June 30, 2009
U7-C-STP-NRC-090070

RE: Application to Amend the Design Certification Rule for the U.S. Advanced Boiling
Water Reactor (ABWR)

Aircraft Impact Assessment and Changes to the ABWR Design Control Document (DCD)

ATTACHMENT 1 – Revisions to the ABWR DCD

Figure 9.5-6 Alternate Feedwater Injection System Schematic

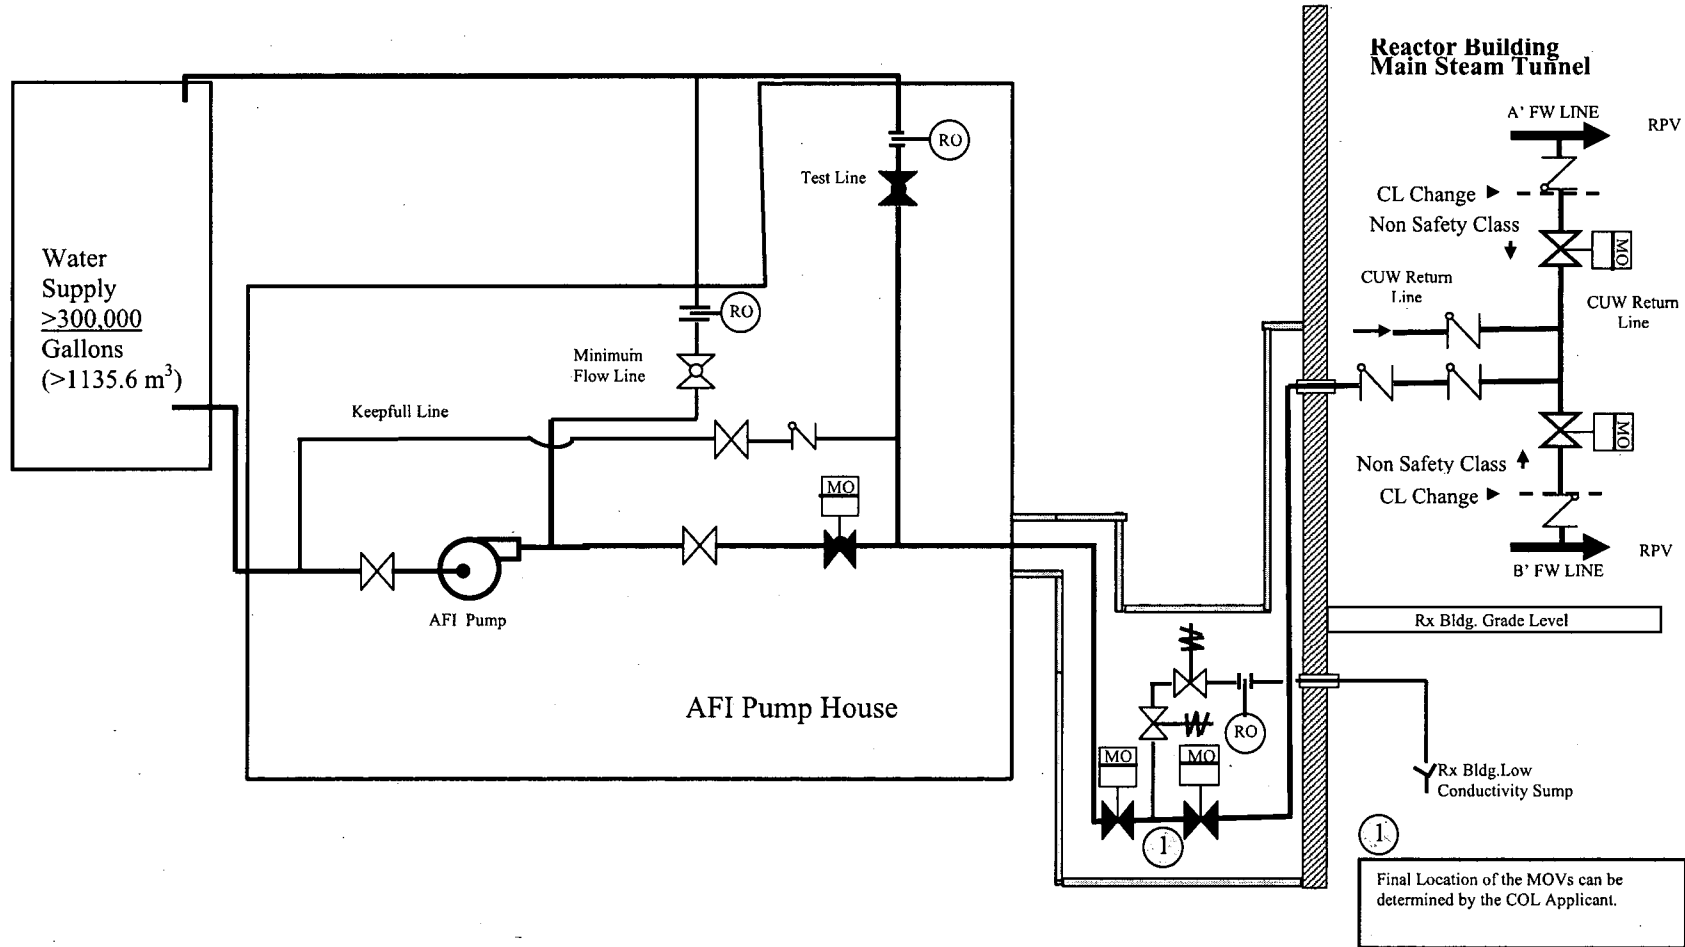
The system can be operated from the AFI Pump House. This will ensure that the injection can be initiated within 30 minutes after the loss of normal makeup systems to provide sufficient core cooling. In addition, the operator is provided with the capability to control flow from the AFI Pump House by throttling a motor- operated valve located in the Pump House.

line and are connected to new level and pressure transmitters. The additional transmitters for RPV water level, RPV pressure and wetwell WR pressure as well as the suppression pool water level transmitter are installed in a room which is protected from fire effects. The room protection is achieved by additional fire doors or modification of fire doors to water-tight doors. In the unlikely event of an instrument line break, the break flow is limited by the small size of the instrument line orifice and is accounted for in the specified capacity for the AFI pump.
